**SUNDRY NOTICES AND REPORTS ON WELLS**  
*Do not use this form for proposals to drill or to re-enter an abandoned well. Use form 3160-3 (APD) for such proposals.*

8. Well Name and No.  
FLORANCE GAS COM 1R

BP America Production Company requests to deepen the subject well.

**FLORANCE GC A 001R-FT**  
Sec 22, T30N, R08W  
**API # 30-045-29202**

# Current WBD

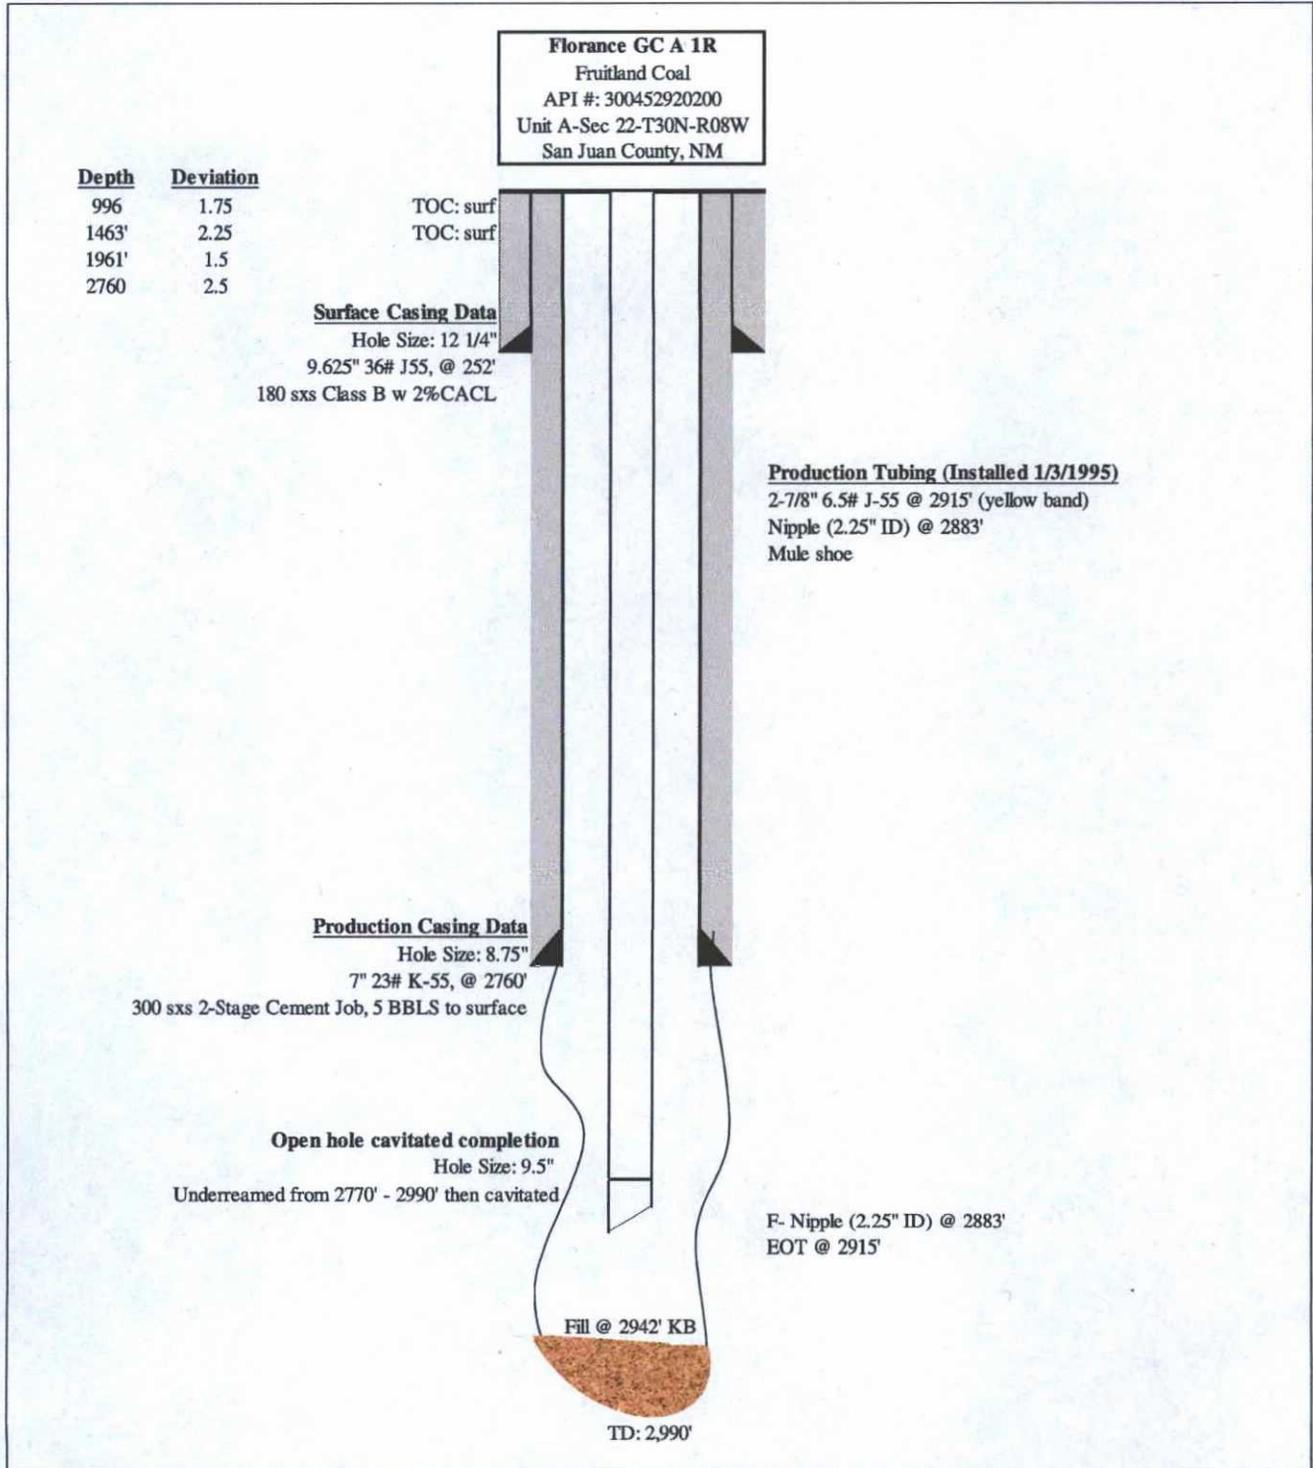
The proposed work is to cleanout, deepen the well to provide additional rathole, install liner, rods and pump to effectively produce the Fruitland Coal formation

1. Pull tubing
2. Deepen well to 3080' ±
3. Run liner – either pre-slotted or perforate after installation; liner might be run with bit and sub on bottom
4. Run tubing
5. Install rods & pump
6. Return well to production

Production Tubing  
 2-3/8" Tbg with mule shoe set at +/- 3,020'  
 Rods & pump

Proposed Production Liner  
 4-1/2" - 5 1/2" liner set at +/- 3080'

TD: +/- 3,080'
